Access Compliance Report Public Rights-of-Way (Pedestrian Signals)

Main Street: BATAVIA_ST Cross Street: LINCOLN_AVE Location: SW

ADA ID: SGAT210924094430 Signal Type: One Push Button-Non APS Overall Compliance: No Severity Scores: BTN 1: 35 BTN 2: N/A No BTN: N/A

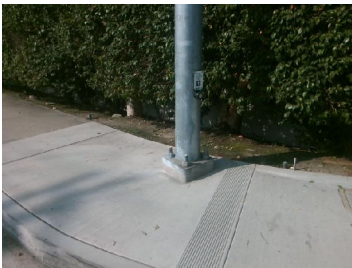
OC Std/PROW: R404.2, MUTCD 4e.08

Possible Solutions: Replace Signal Push Button With APS Button. Remove and Replace Clear Space.
